CITY OF ALBUQUERQUE

**RE: Broadstone Highlands East Block
Grading and Drainage Plan
Engineer's Stamp Date: 1/24/18
Hydrology File: K15D034C**

Based on the information provided in the submittal received on 1/25/18 the above-referenced Grading and Drainage Plan cannot be approved for Site Plan for Building Permit until the following are corrected:

CONCEPTUAL
GRADING & DRAINAGE PLAN

C1.00

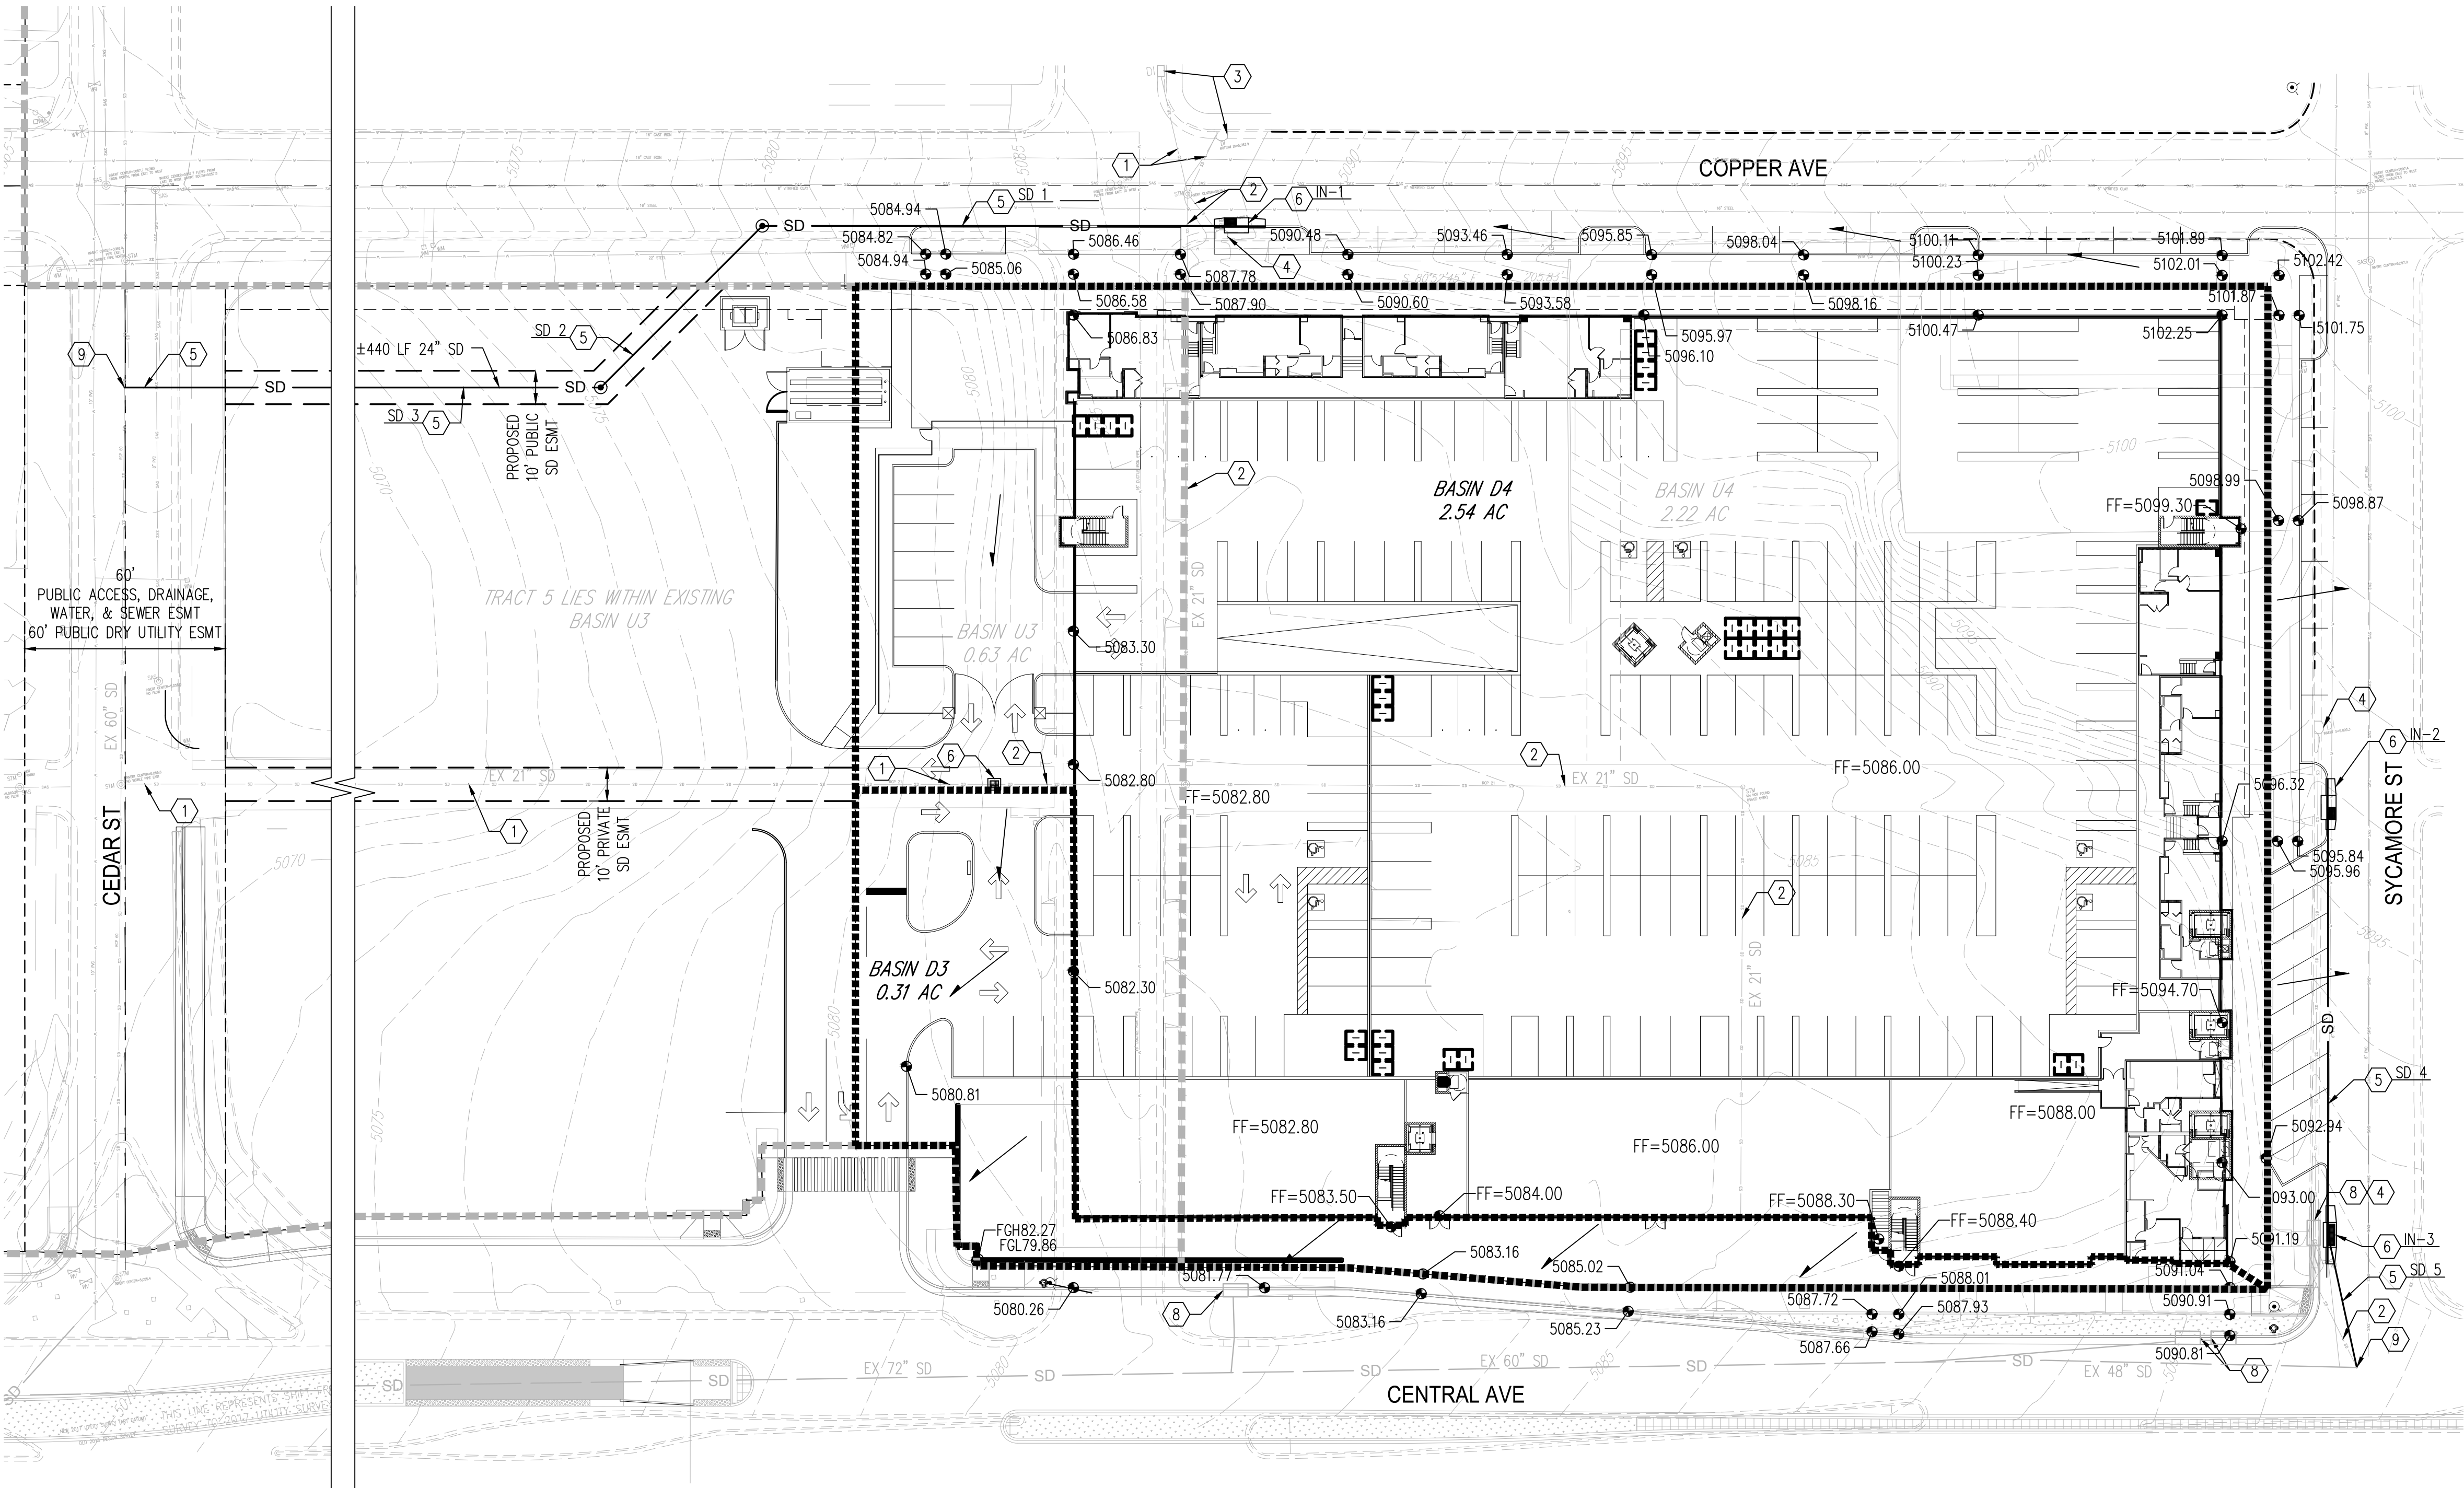
1. Include an off-site subbasin map, including topographic data.
2. Clarify roof drainage and show on plans.
3. Label all Public vs. Private drainage improvements and ensure all improvements in the public ROW are on the infrastructure list.
4. Clarify how the connections to existing storm drain will be made (keyed note 9). If there is no existing manhole to connect to, a new manhole will need to be built and included on the infrastructure list.
5. The new public storm drain easement (recorded) needs to be included on the infrastructure list. Provide a trenching prism at deepest point to evaluate the required width. The width will need to be at least 20' per DPM Ch.22, Section 6, Part C.
